Proposal to update the specification of 2km optical PMDs

Guangcan Mi, Ping Liao, Huijian Zhang
Huawei Technologies Co., Ltd

Introduction

A 3-tap FFE analogy: analytical analysis

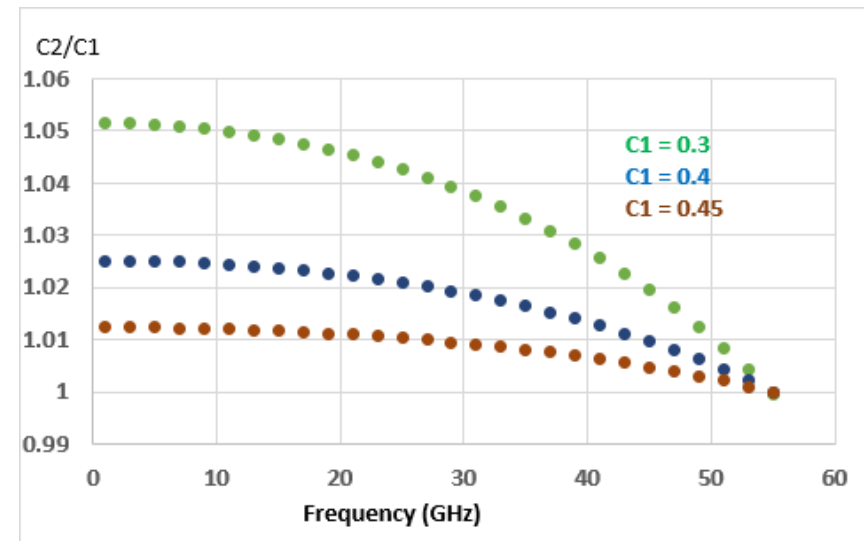
- Assume tap weights $[-c_1, c_0, -c_1]$ @ $f_1 \Rightarrow 106.25\text{GB}$ and $[-c_2, c_0, -c_2]$ @ $f_2 \Rightarrow 113.4375\text{GB}$.
- For the transmitter to get stronger equalization @ 113.4375GB , the amplitude of the equalizer's frequency response should be higher than that for 106.25GB , the relation between c_1 and c_2 is as following:

$$\text{To satisfy } H\left(\frac{2\pi f}{f_1}\right) \geq H\left(\frac{2\pi f}{f_2}\right)$$

We need:

$$c_2 \geq \frac{\left(1 - \cos\left(\frac{2\pi f}{f_1}\right)\right) * c_1}{1 - \cos\left(\frac{2\pi f}{f_2}\right) + 2 * c_1 * \left(\cos\left(\frac{2\pi f}{f_2}\right) - \cos\left(\frac{2\pi f}{f_1}\right)\right)}$$

$$\text{where } f_2 > f_1, 0 < f \leq \frac{f_1}{2}$$

1. The ratio of c_2/c_1 varies monotonically with frequency, with its maximum value occurs at $f=0$:

$$c_{2_{max}} = (c_1 * f_2 / f_1) / \left(\frac{f_1}{f_2} - 2 * c_1 * \left(\frac{f_1}{f_2} - \frac{f_2}{f_1}\right)\right) \quad \text{for } f = 0$$

2. The ratio of c_2/c_1 decreases with higher value of c_1 . For a tap limit > 0.4 , the difference is a minimal value of 0.01
